Re: Embry-Riddle Aeronautical University Fitness Complex

Addendum 2 –Narrative Project Number: 20-001

12 W1.S1.0

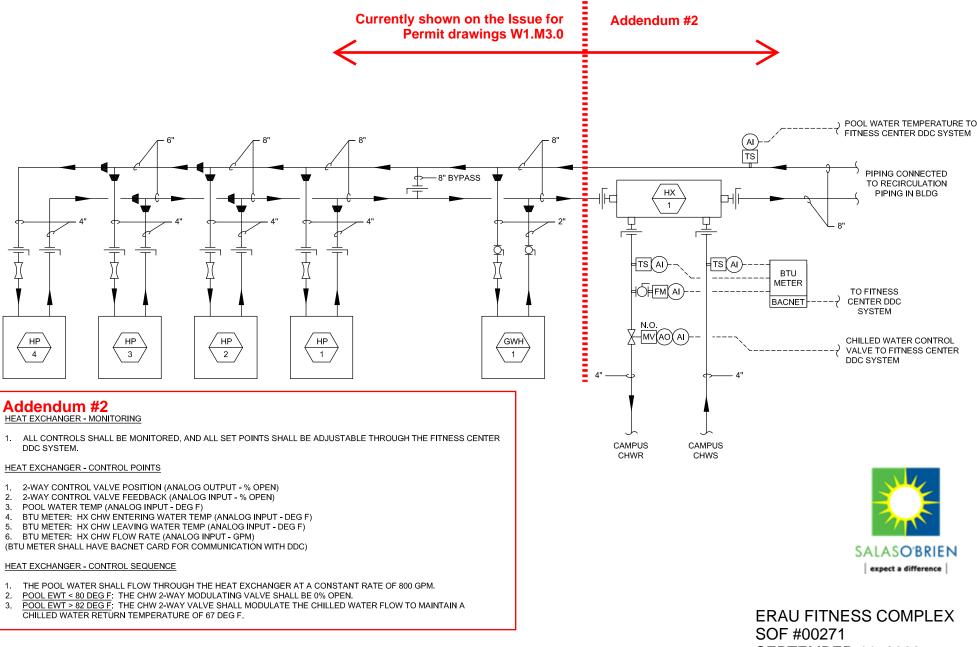
1. See attached sketch revising detail 12/W1.S1.0 reflecting new dimensions.
